UTPB - VALET AND DRIVEWAY RENOVATION
6410 Fannin Street/ Houston, Texas 77030

Date: December 16, 2019
Johnston Project No.: 19-00032-00
Prepared by: Paula Gaviria

1. This Addendum addresses architectural, mechanical and electrical revisions as noted below, per comments from EH&S:

1 MECHANICAL ENTRY LEVEL
1/4" = 1'-0"

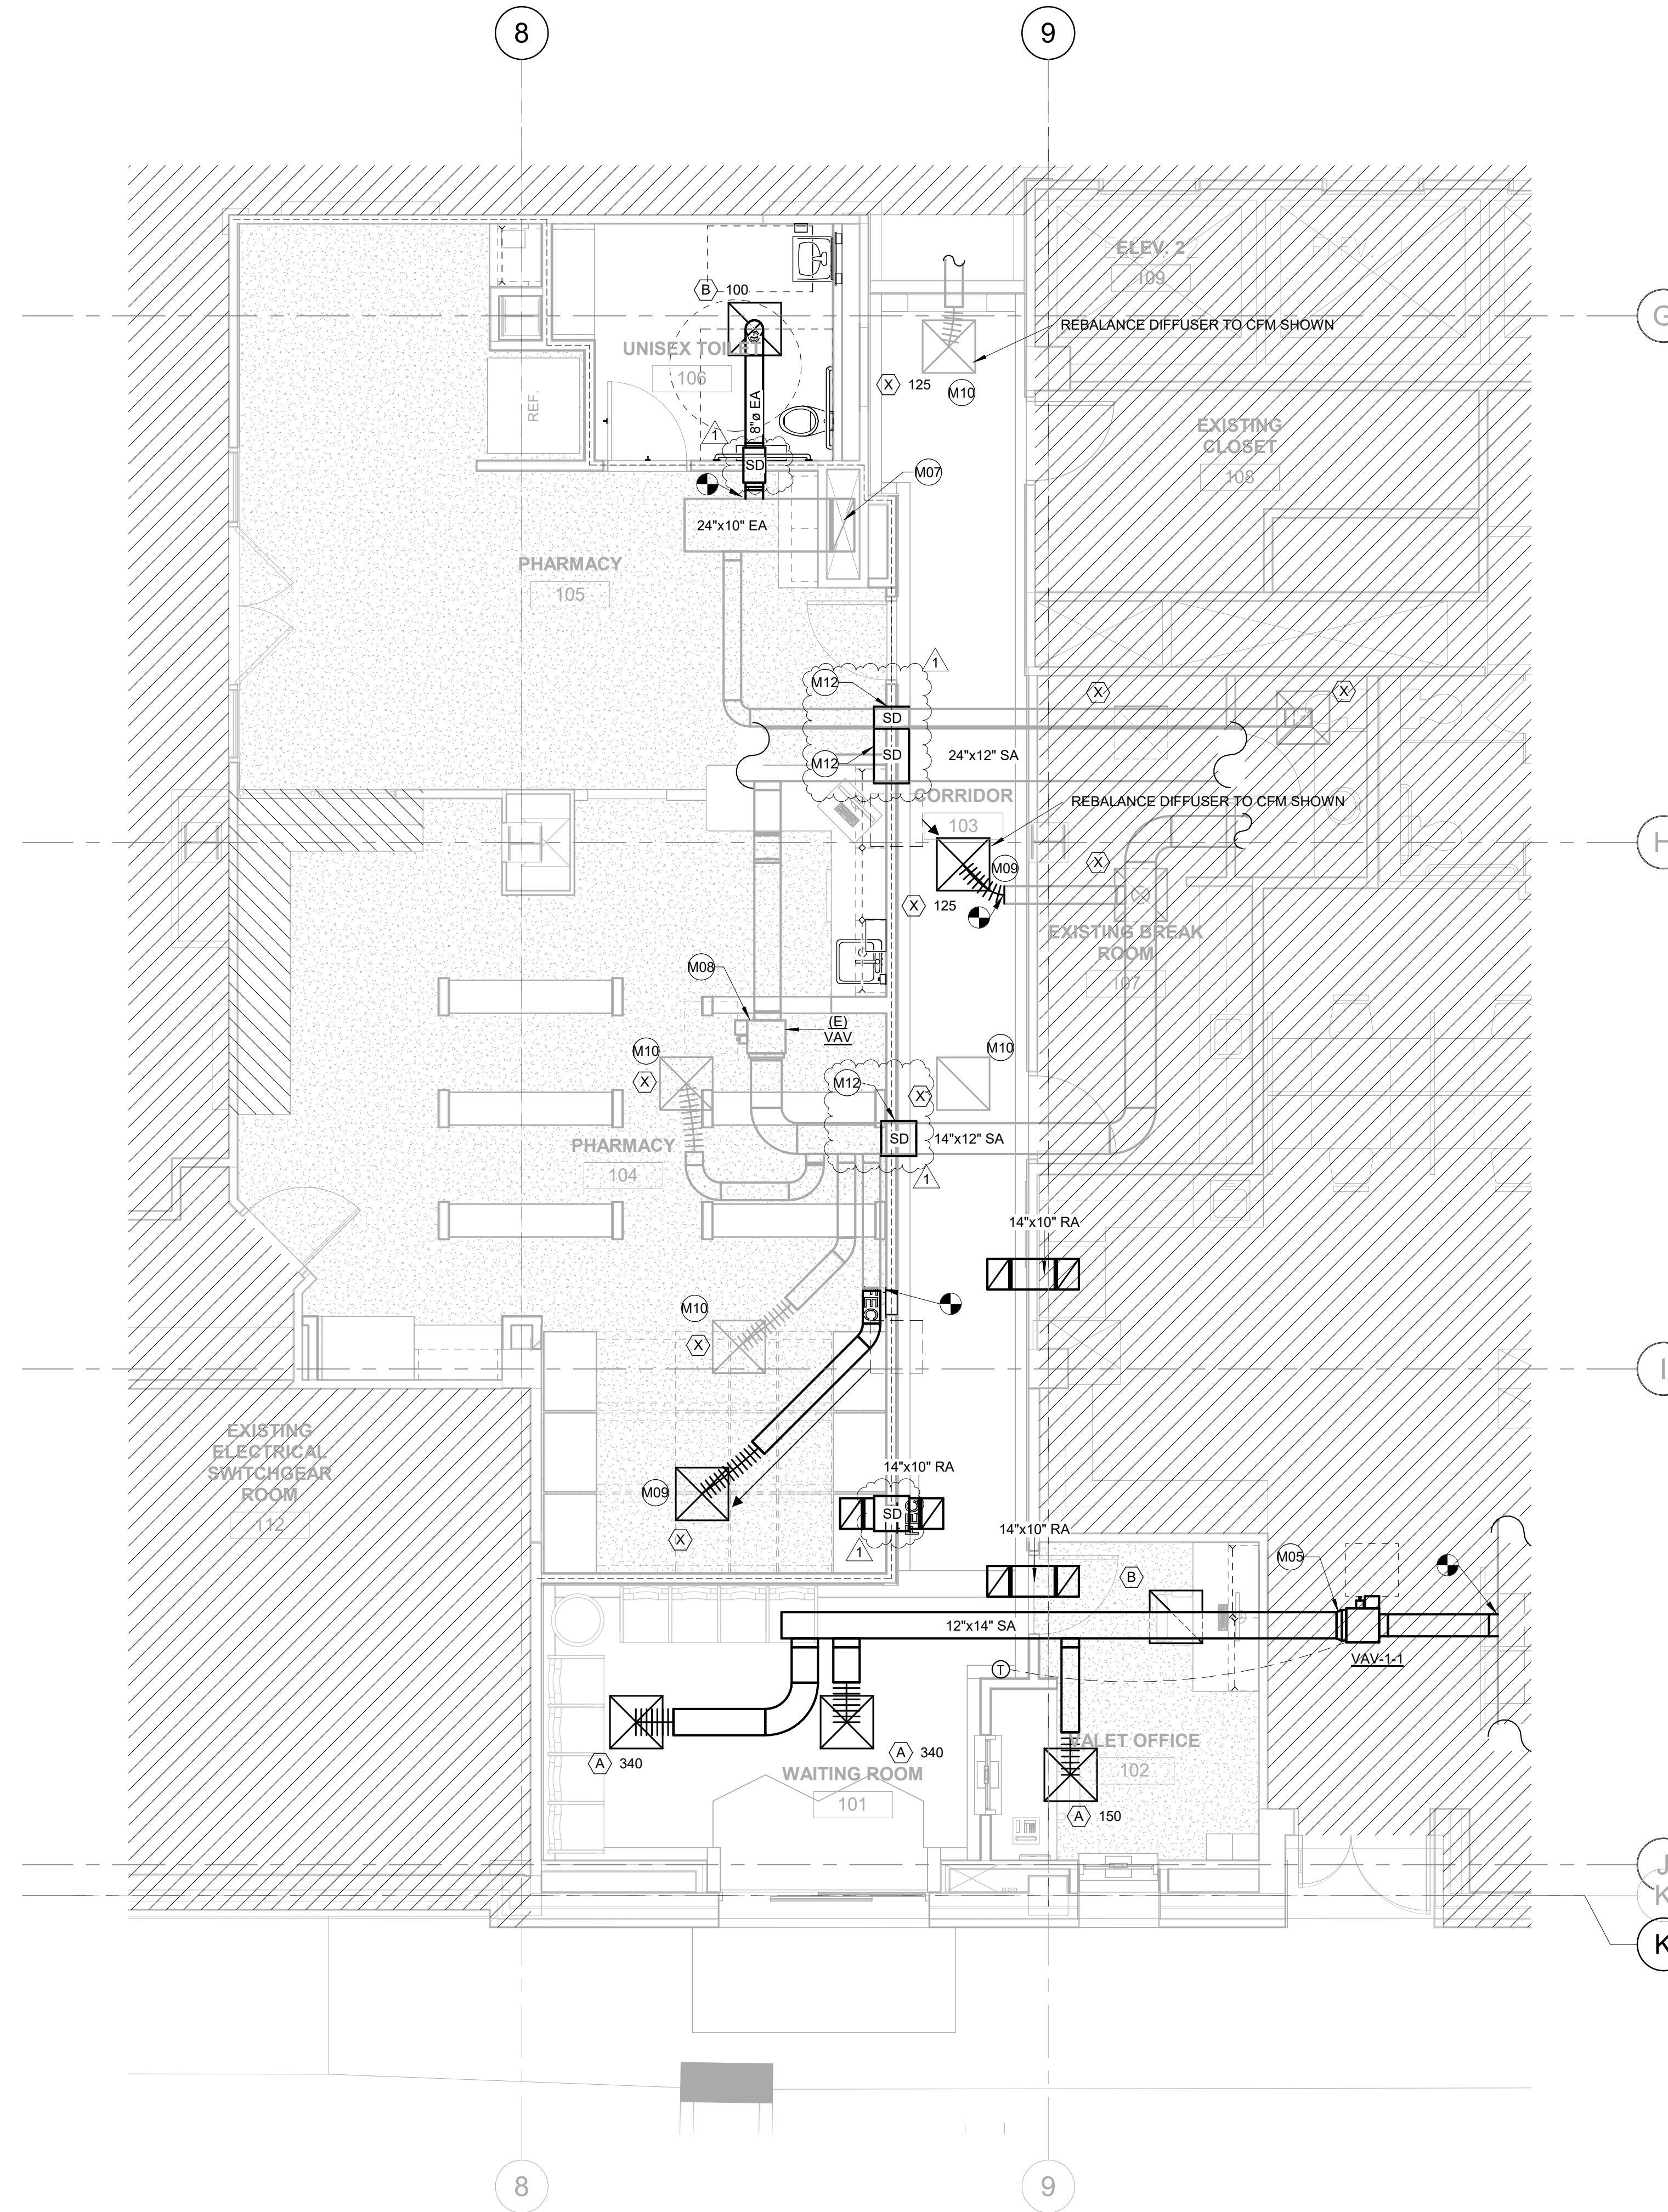
1. M0.01: MECHANICAL SCHEDULES, CONTROLS, AND DETAILS
 - Replaced detail for smoke dampers.
2. M2.01: MECHANICAL DUCTWORK PLAN – LEVEL 1
 - Revised keynote number 12 referring to smoke damper installation.

- M05 INSTALL NEW VAV. RE-BALANCE EXISTING AHU TO ACCOMMODATE NEW VAV BOX. REF: SCHEDULE.
- M07 BALANCE EXHAUST RISER.
- M08 TAKE PRE-READINGS AND REBALANCE-TERMINAL UNIT. AFTER SETTING AIRFLOW AT DIFFUSER IN CORRIDOR. RELOCATE THERMOSTAT IF NECESSARY
- M09 RELOCATE EXISTING DIFFUSER TO NEW LOCATION, EXTEND DUCT AS NECESSARY. REF: M2.01.
- M12 INSTALL SMOKE DAMPER INTO EXISTING DUCTWORK.

1 ELECTRICAL SITE PLAN
3/32" = 1'-0"

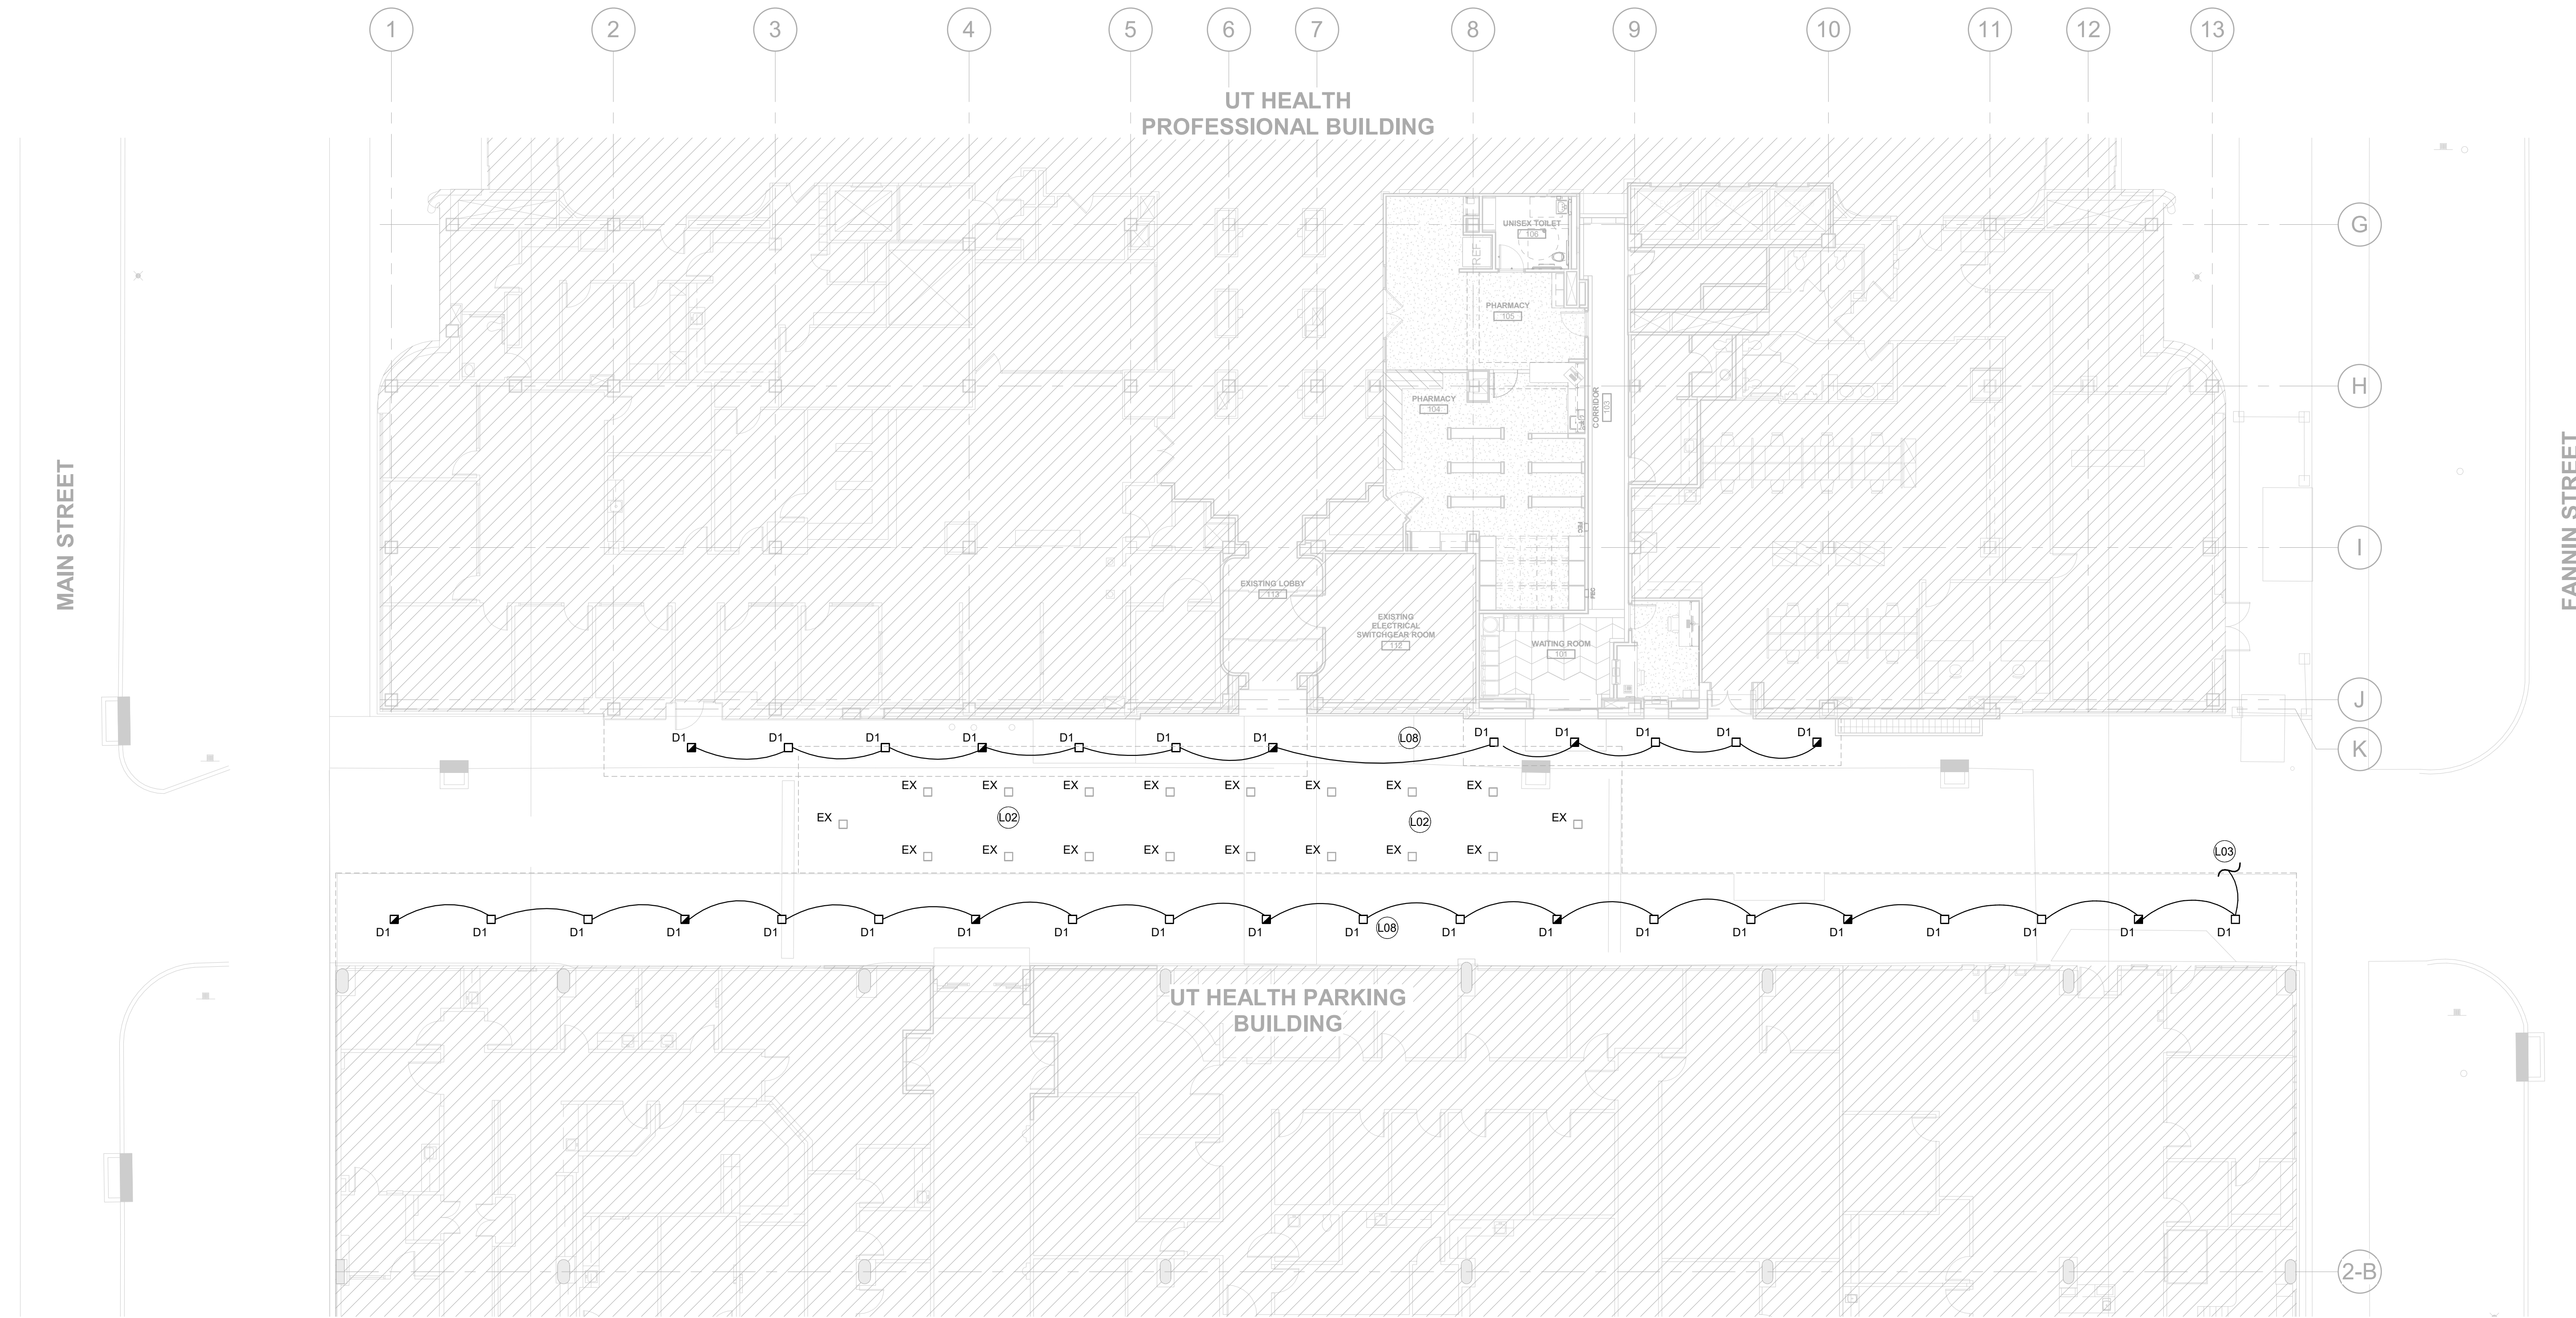
1. E1.01: ELECTRICAL SITE PLAN
 - Revised keynote L03 referring to existing lights
2. E2.01: ELECTRICAL LIGHTING PLAN – LEVEL 1
 - Revised emergency lighting in Waiting Room and Valet Office.
 - Added exit sign to Corridor.
3. E3.01: ELECTRICAL POWER PLAN – LEVEL 1
 - Added outlets to Corridor and Valet Office.
4. E5.01: ELECTRICAL FIRE ALARM PLAN – LEVEL 1
 - Added fire alarm pull string to Waiting Room.
 - Added and relocated fire strobes.
 - Added a smoke detector to Pharmacy.

- L02 LIGHT FIXTURES ARE EXISTING TO REMAIN UNLESS NOTED OTHERWISE, (TYPICAL)
- L03 VERIFY THAT A PORTION OF THE CANOPY LIGHTS ARE SERVED FROM AN EMERGENCY CIRCUIT. IF NONE ARE SERVED FROM AN EMERGENCY CIRCUIT(S), PROVIDE NEW EMERGENCY CIRCUIT(S) AS REQUIRED TO SERVE CANOPY LIGHTS, AND SERVE INDICATED FIXTURES FROM EMERGENCY CIRCUIT(S). NEW LIGHT FIXTURES ARE TO BE REPLACED IN LOCATION CURRENTLY OCCUPIED BY EXISTING FIXTURES.
- L08 REPAIR, PATCH AND PAINT CANOPY TO RESTORE TO ORIGINAL CONDITIONS.
